Rezoning Application: PD 26-0426

APPLICATION NUMBER: PD 26-0426

CITRUS PARK MULTI-FAMILY PLANNED DEVELOPMENT GENERAL SITE PLAN

AGENCY REVIEW COMMENT SHEET

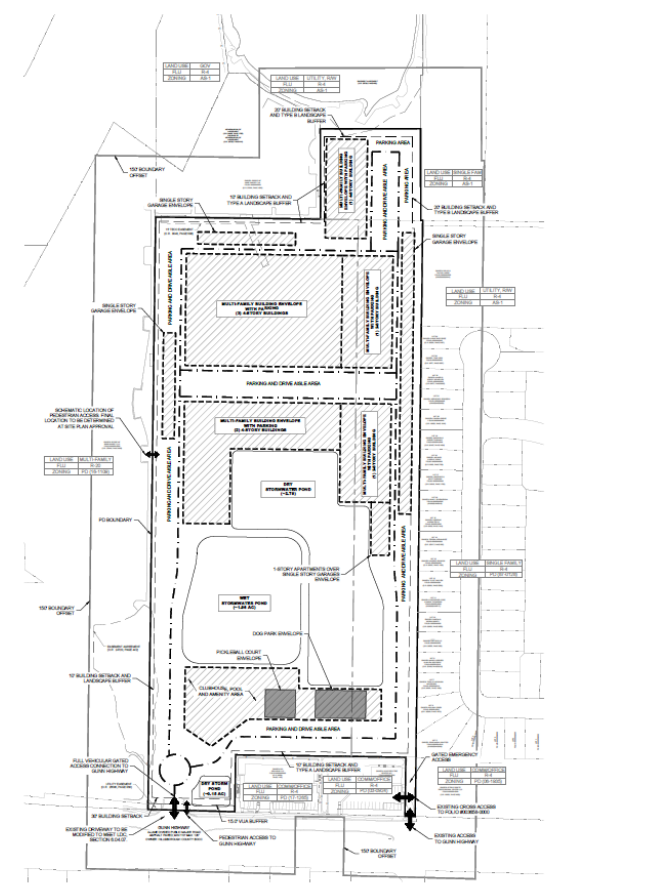
1. Prior to PD General Site Plan certification, the applicant shall revise the PD site plan label stating “Existing driveway to be modified to meet LDC, Section 6.04.07.” to “Existing driveway to be modified to meet the LDC, Sec. 6.04.04.A.3. residential development maximum driveway length.”
2. Prior to General Site Plan certification, the applicant shall revise the PD site plan proposed general vehicular general circulation pattern to connect to the proposed gated emergency access.
3. General Site Plan to provide a maximum building height for the amenity center at 35 feet.

- Prior to PD site plan certification, the applicant shall revise the PD site plan label stating “Existing driveway to be modified to meet LDC, Section 6.04.07.” to “Existing driveway to be modified to meet the LDC, Sec. 6.04.04.A.3. residential development maximum driveway length.”
- Prior to PD site plan certification, the applicant shall revise the PD site plan proposed general vehicular general circulation pattern to connect to the proposed gated emergency access.
